County of Fairfax, Virginia

Re: Interpretation for PCA 1999-HM-011/FDPA 1999-HM-011-1-2, Van Metre at Woodland Park, Tax Map Number 16-3 ((1)) 25D2: building and parking layout, landscaping

Re: Interpretation Request for PCA 1999-HM-001 / FDPA 1999-HM-011-1-2
Van Metre at Woodland Park
Tax Map Reference: 16-3((1)) 25D2 (the "Subject Property")

LANDSCAPE PLAN
Ex. F

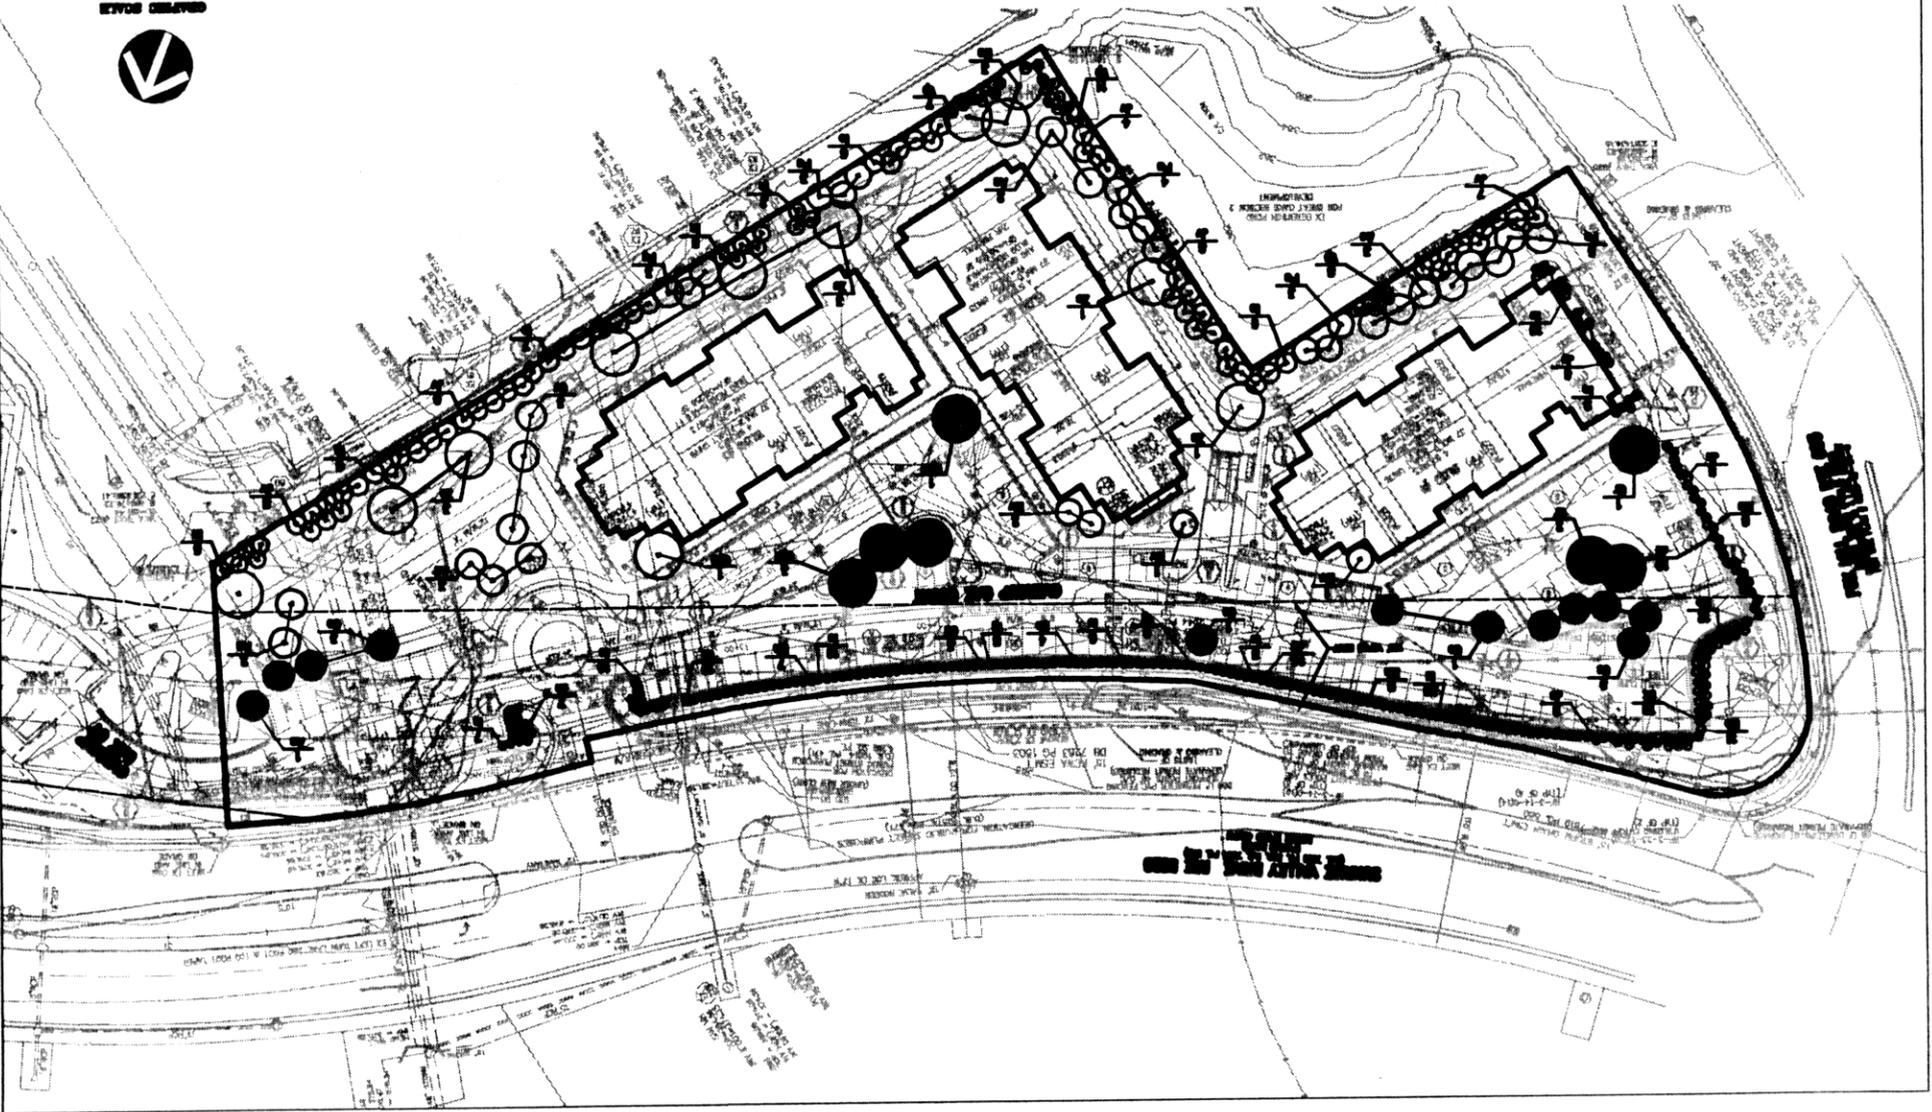
1. a revision to the area planned as an optional pool and clubhouse in order to provide an additional walkway and benches in addition to the lawn area and landscaping;
2. a revised landscape plan providing some variation in height of the plant material used along Sunrise Valley Drive; and
3. provision of a parking tabulation.

frontage between the sidewalk and the parking lot. Where previously the plants were low shrubs; the new plan includes groupings of Leatherleaf Mahonia (mature height expected of 10 feet), Inkberry (mature height of eight feet), and Sea Green Juniper (mature height of six feet), intermixed with Japanese Holly (mature height of five feet) and Willowleaf Cotoneaster (mature height of three feet). This combination of plants should provide a variety of heights along the streetscape. (An 8 ½" by 11" reduction has been provided.)

It is my determination that the proposed building and parking layout, and landscaping are in substantial conformance with the proffers and the CDPA/FDPA, subject to final approval by Urban Forest Management, DPWES. This determination has been made in my capacity as the duly authorized agent of the Zoning Administrator and addresses only the questions contained in your request as discussed above.
